CITY OF DALLAS

RE: Appeal of Certificate of Appropriateness:
Hearing – October 3, 2022
4512-4518 Sycamore St., Case No. CA212-354(RD)

**4512-4518 SYCAMORE
STREET
APPEAL
CA212-354(RD)**

**City Plan Commission
Hearing
01/05/2023**

Photo #1 (duplex #1)

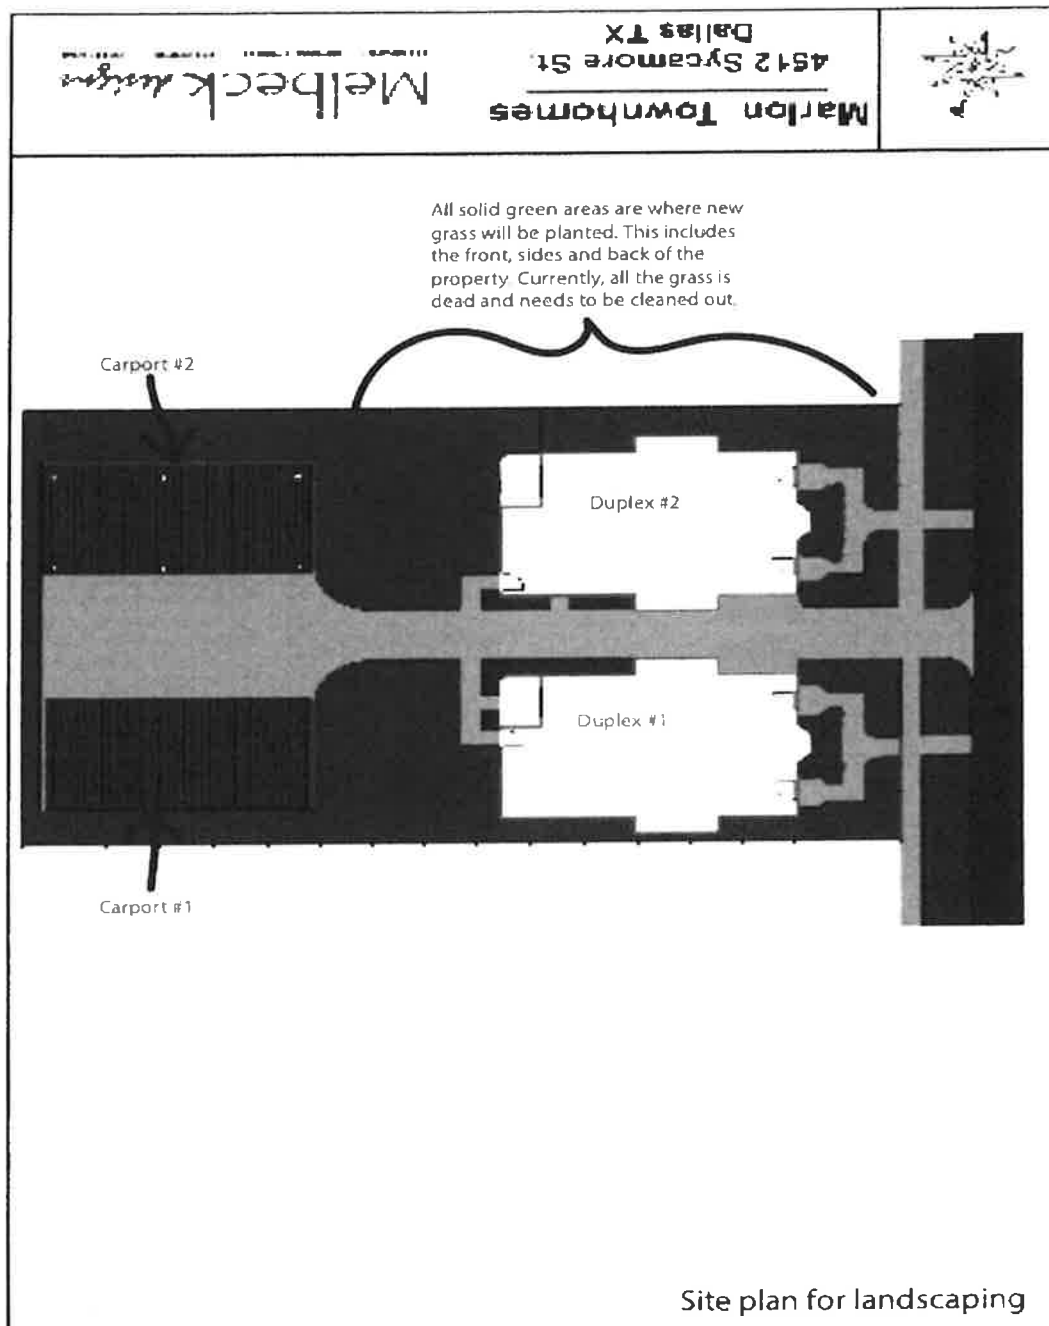
Photos #3 & #4: These two photos are of the back of each duplex next to the carports. These areas once had grass, but it has since died and we are unable to do anything other than have the two areas cleaned out and have new grass put in. New grass will help with the overall appearance and integrity of the property, as well as provide residents with a sightly and manicured property.

SASH - EXPLODED VIEW

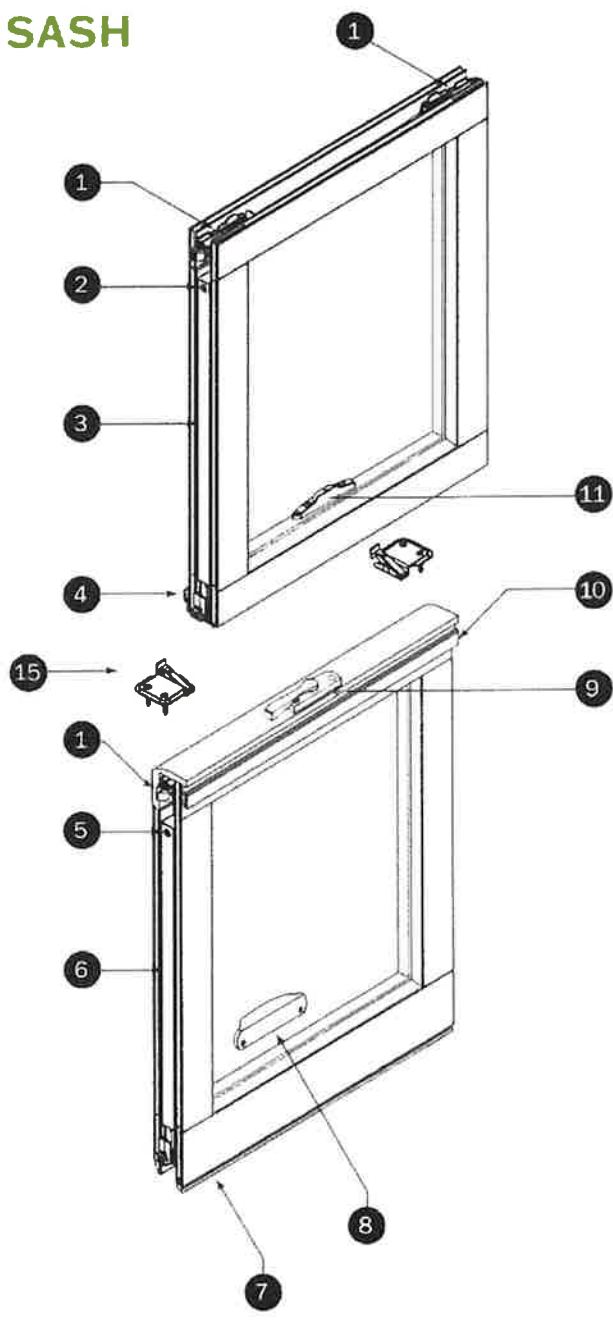
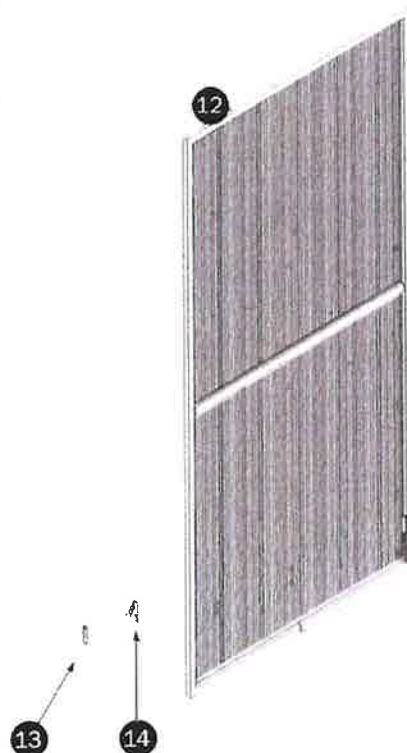
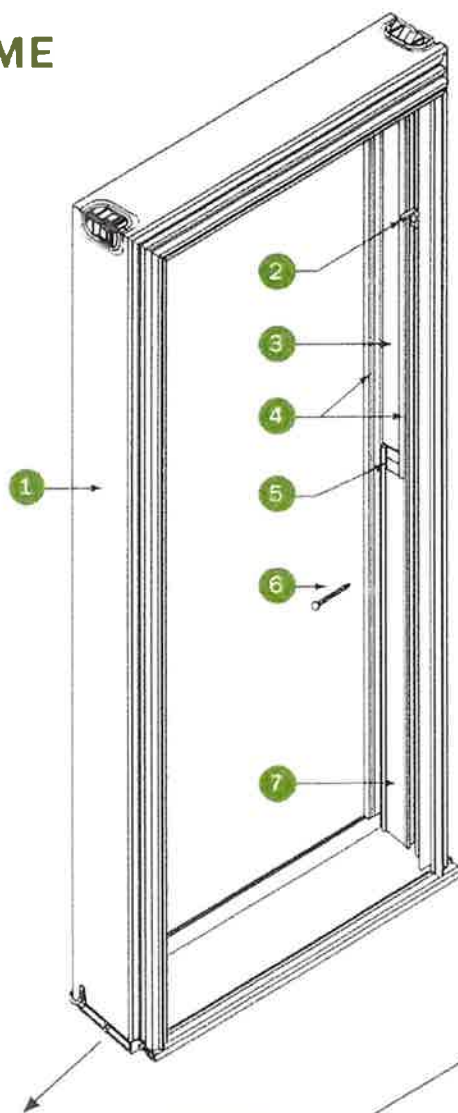
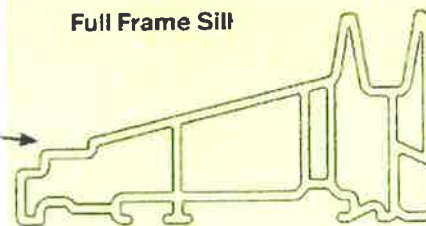
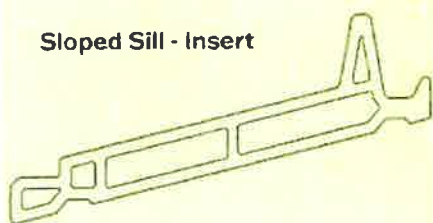
11 COMMISSIONER ANDERSON: Second
12 question is the wood composite windows.
13 This historic district requires wood
14 windows. We do not allow things such as
15 Hardie Board because it's an imitation
16 material. So I'd like to get more
17 information on what wood composite
18 windows are and how they are to be used
19 in this historic district.

2 don't see on the detail that's provided
3 that -- it looks like the meeting sash
4 is the same dimension as the side rail
5 sashes and the top rail sashes. I don't
6 see a difference between your meeting
7 rail sash. That's a very prominent
8 feature on historical windows, interior
9 windows, and I don't see that.

14 COMMISSIONER CUMMINGS: No, I'm
15 talking about the bottom sash. There's
16 also indications of differences on the
17 thickness of the meeting sash, but let's
18 just talk about the bottom sash. What's
19 your dimension on your bottom sash? And
20 I also don't see a sill detail that was
21 called out, and you had three choices on
22 the windowsills.

11 COMMISSIONER CUMMINGS: Correct.
12 It doesn't seem like there's a
13 difference between the bottom sash
14 dimension and the side dimension.

5. That the request for a Certificate of Appropriateness to replace wood windows with wood composite windows be **denied**. Wood composition windows are not wood, and these windows would have an adverse effect on the historic district. Work is not consistent with 51A-4.501(g)(6)(c)(ii) for non-contributing structures. Proposed work is not compatible with the historic district.
